Mulga Downs Iron Ore Mine – Assessment No. 2326 – Environmental Review Document – Response to Submissions

Table 1 Comments From EPA Services

Figure 1-4: Water Supply Bores

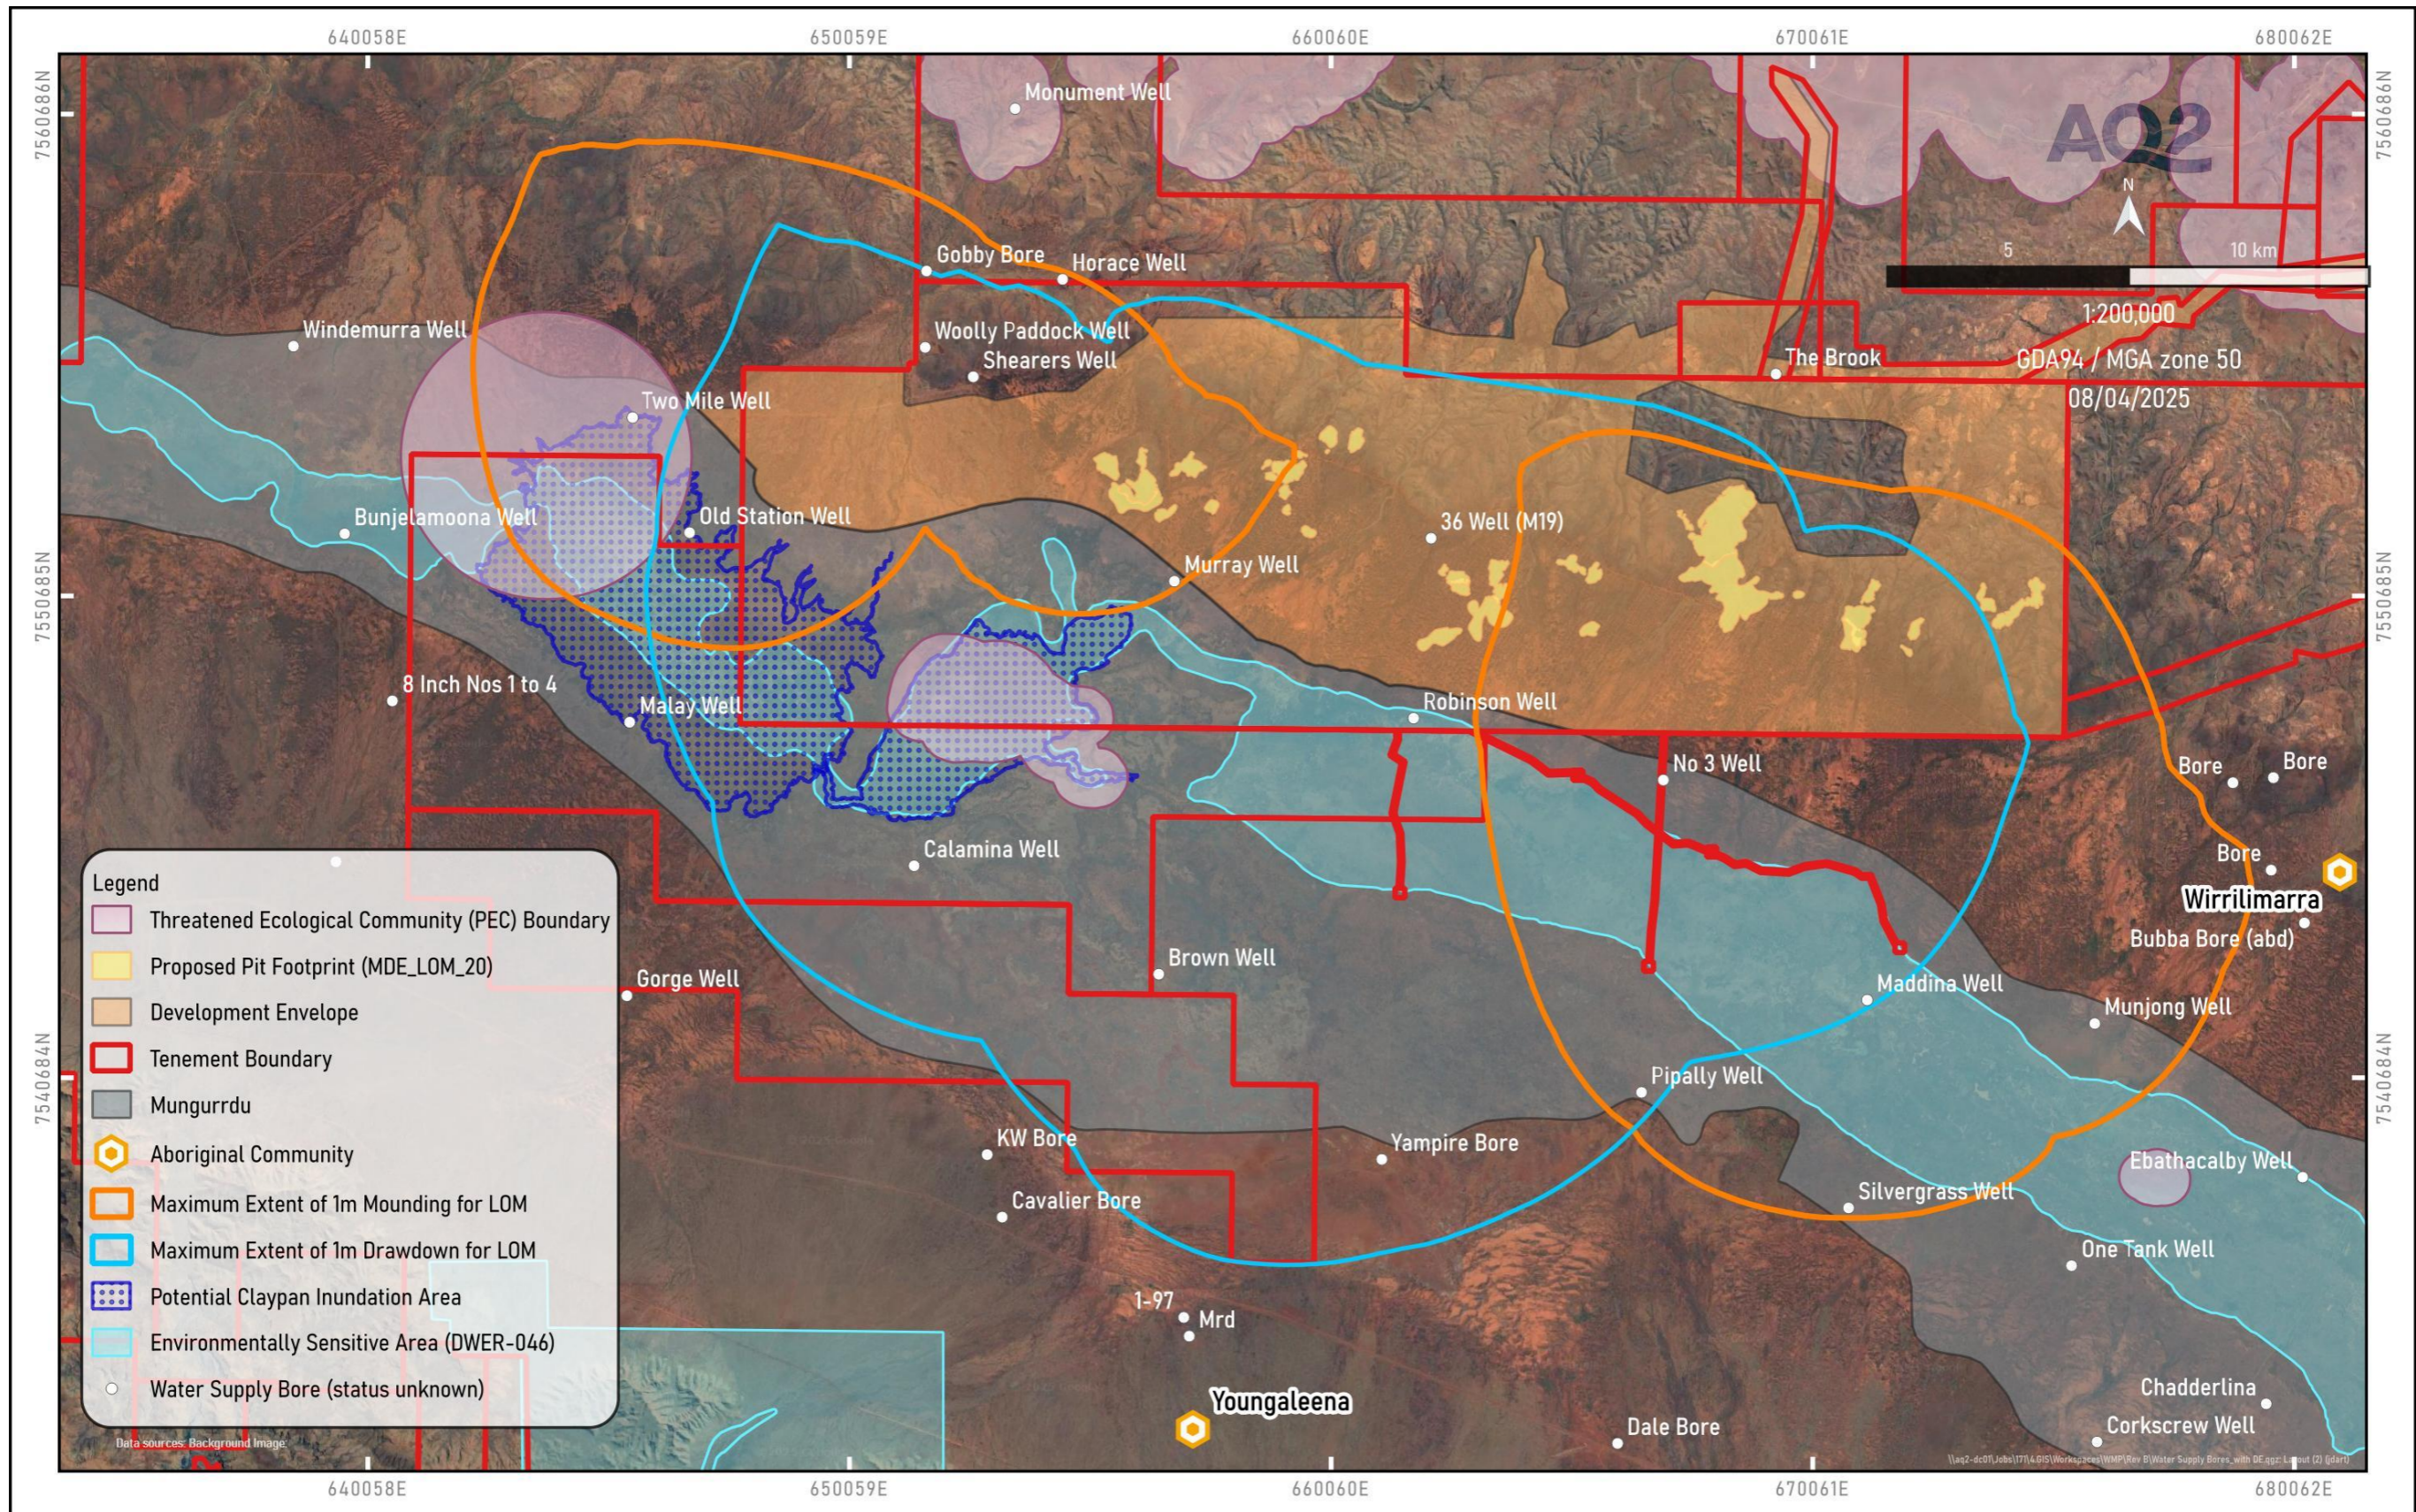
17. It is unclear whether the bores in white in Figure 1-4 (and Figure A3-1) of the WMP represent pastoral bores only, or whether there are bores with other uses. It is also unclear whether the bores as shown by the ‘Community’ symbol are the only bores used by communities, or whether any other bores in Figure 1-4 are also utilised. Further, Figure 1-4 should be updated to include Rio Tinto and Fortescue operational bores.

“It is unclear whether the bores in white in Figure 1-4 (and Figure A3-1) of the WMP represent pastoral bores only, or whether there are bores with other uses. It is also unclear whether the bores as shown by the ‘Community’ symbol are the only bores used by communities, or whether any other bores in Figure 1-4 are also utilised. Further, Figure 1-4 should be updated to include Rio Tinto and Fortescue operational bores.

Figure 1-4 in the WMP presents the locations of the Youngaleena and Wirrilimarra Communities as well as bores and wells from DWER’s Water Information Reporting (WIR) database. Predominantly these are pastoralist water supplies, although some (if not all) of the unnamed bores in the vicinity of Wirrilimarra, are associated with Fortescue’s White Knight exploration area.

Figure 1-4 in the WMP presents the locations of the Youngaleena and Wirrilimurra Communities as well as bores and wells from DWER’s Water Information Reporting (WIR) database. Predominantly these are pastoralist water supplies, although some (if not all) of the unnamed bores in the vicinity of Wirrilimurra, are associated with Fortescue’s White Knight exploration area.

We note that Figure 4-1 should have been incorporated in Appendix 3 of the WMP as Figure A3-1 (instead of the Ground User Water Supply Bores figure). This may have led to the confusion.
